# United States Patent and Trademark Office

APPLICATION NO.	FILING DATE	FIRST NAMED INVENTOR	ATTORNEY DOCKET NO.	CONFIRMATION NO	
10/662,244	09/16/2003	Lyle J. Christiansen		2385	
759	90 05/18/2005		EXAM	INER	
Lyle J. Christiansen			NGUYEN, JIMMY T		
701 Imperial Drive Morris, MN 56267			ART UNIT	PAPER NUMBER	
			3725	3725	
	*		DATE MAILED: 05/18/2009

### **DETAILED ACTION**

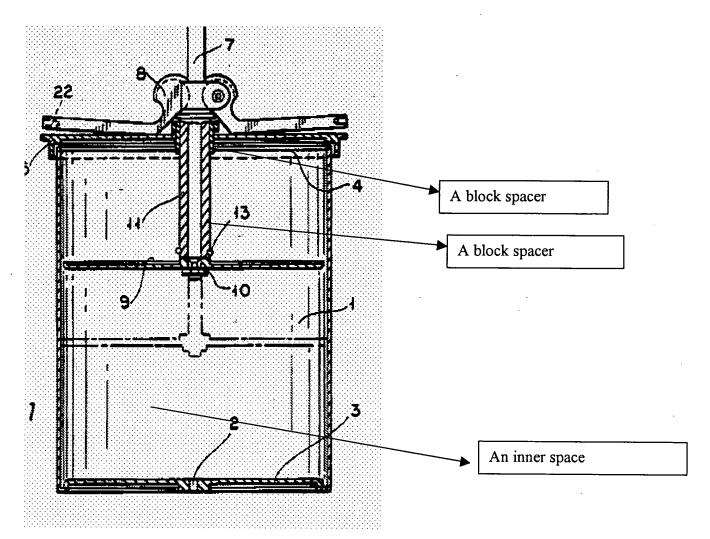
Regarding claim 3, Rodolico discloses a crusher comprising: an elongated container (1) with a top cover (5), a bottom cover (3), an attached strike plate (9), handles (8); miscellaneous bolts (15), nuts (10, 20); washers (16), and block spacers (11 and an element shown in the illustration below). Examiner interprets element (11) as one of the spacers because it is being arranged in the space between the rod (7) and the top cover (5), and the element as shown in the illustration below as the other block spacer because it is being arranged in the space between the block spacer (11) and the top cover (5). Rodolico discloses the container having an inner spacer (see below), thus a heavy granular material can be placed in the inner space of the container.

Regarding claim 4, the miscellaneous bolts and the handles can be removed and placed inside a body of the container. Each of the bolts can be removed by unscrewed the bolts from the respective handles and the handles can be removed out of the block spacer (11) after the respective bolts are removed.
